#### HISTORIC AND DESIGN REVIEW COMMISSION

July 06, 2016 Agenda Item No: 25

HDRC CASE NO: ADDRESS: LEGAL DESCRIPTION: ZONING: CITY COUNCIL DIST.: DISTRICT: LANDMARK: APPLICANT: OWNER: TYPE OF WORK: 2016-243 114 SOLEDAD ST NCB 106 BLK LOT A12 THRU A16 114 TO 128 SOLEDAD ST D H HS RIO-3 1 Main/Military Plaza Historic District Masonic Building / Old Bexar County Courthouse David Merritt/Merritt Development Group Michael Harrell/VistaHost Demolition with new construction

The applicant is requesting conceptual approval to demolish the structure at 114 Soledad Street, commonly known as the Solo Serve Building, with the exception of the stone retaining wall and construct a new hotel to feature a total of nine levels, including the Riverwalk level. The stone retaining wall on the river side constructed circa 1914 is to be incorporated into the design of the new construction.

## SITE PLAN

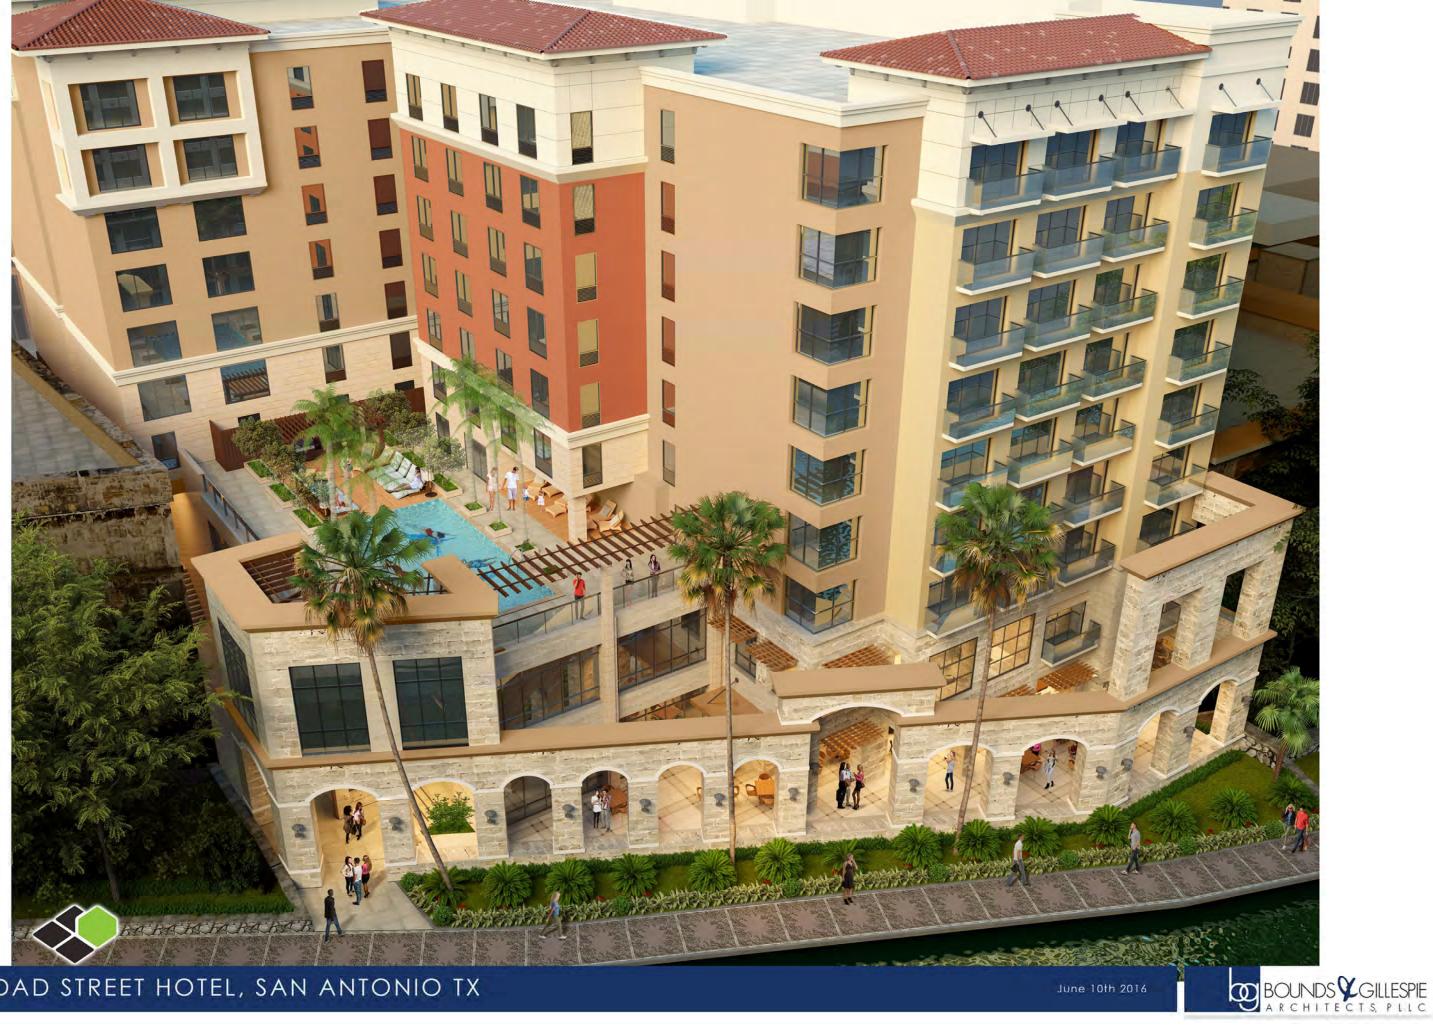
- h. PEDESTRIAN CIRCULATION Per the UDC Section 35-672(a) in regards to pedestrian circulation, an applicant shall provide pedestrian access among properties to integrate neighborhoods. The applicant has provided a site plan that notes public access ways across the site from Soledad Street to the Riverwalk. Additionally, the applicant has connected the various functions of the site in a coordinated system. This is consistent with the UDC.

- SITE DESIGN According to the UDC Section 35-673, buildings should be sited to help define active spaces for area users, provide pedestrian connections between sites, help animate the street scene and define street edges. Primary entrances should be oriented toward the street and shall be distinguishable by an architectural feature. Staff finds the applicant's proposal appropriate and consistent with the UDC in regards to providing clearly defined pedestrian access points, activity nodes that will not only activate the site, but also the public right of way.

- m. LANDSCAPE DESIGN Per the UDC Section 35-673(e) regarding landscape design, a variety in landscape design must be provided with no more than seventy-five (75) percent of the landscape materials, including plants being the same as those on adjacent properties. Additionally, according to the UDC Section 35-674(f), indigenous, non-invasive plant species and tropical plant species are permitted. The applicant has noted all

landscaping location and has noted that native plant materials will be used. This is consistent with the UDC. The applicant will need to provide a final, detailed landscaping plan when requesting a Certificate of Appropriateness.

RIVERWALK ELEVATION

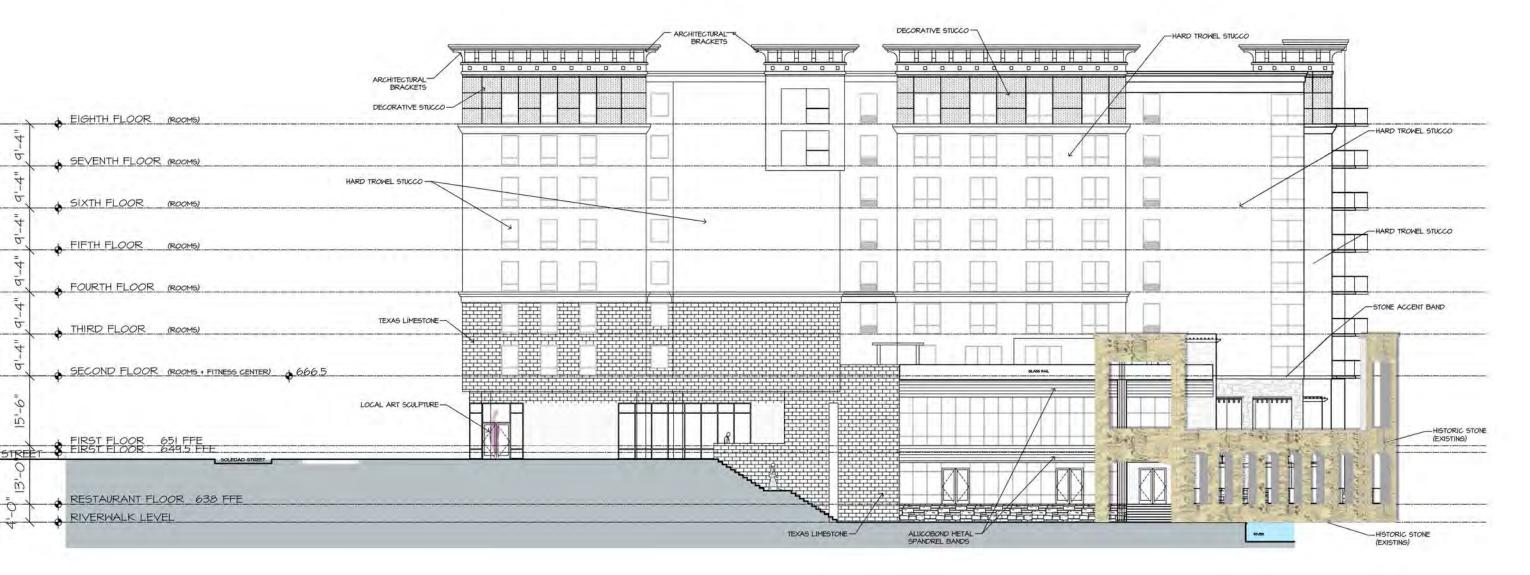
- e. DEMOLITION A detailed demolition plan with a proposal for salvaging will be required before a Certificate of Appropriateness may be issued. While the applicant has indicated that the historic stone retaining wall along the River Walk will be retained, the extent of the demolition of the Solo Serve building and its adjoining stone wall remains unclear. Any historic construction materials, such as the stone foundation elements which are likely remnants of the original Bexar County Courthouse, should be salvaged and stored on site for future integration into the development.

- z. STONE WALL There currently exists a stone retaining wall at the Riverwalk level which the applicant has proposed to incorporate into the new construction. The applicant has proposed to modify the existing wall to include both square and arched openings that are to serve as a buffer between public and private space. Staff finds the applicant's proposed use of the existing stone appropriate and a contemporary interpretation of a fundamental architecturally elements which utilizes historic materials. The applicant has incorporated proportions and dimensions into the proposed wall that are consistent with WPA and Hugman features. Additionally, staff finds that the applicant should provide information regarding the reuse of existing masonry materials currently located within alley ways.
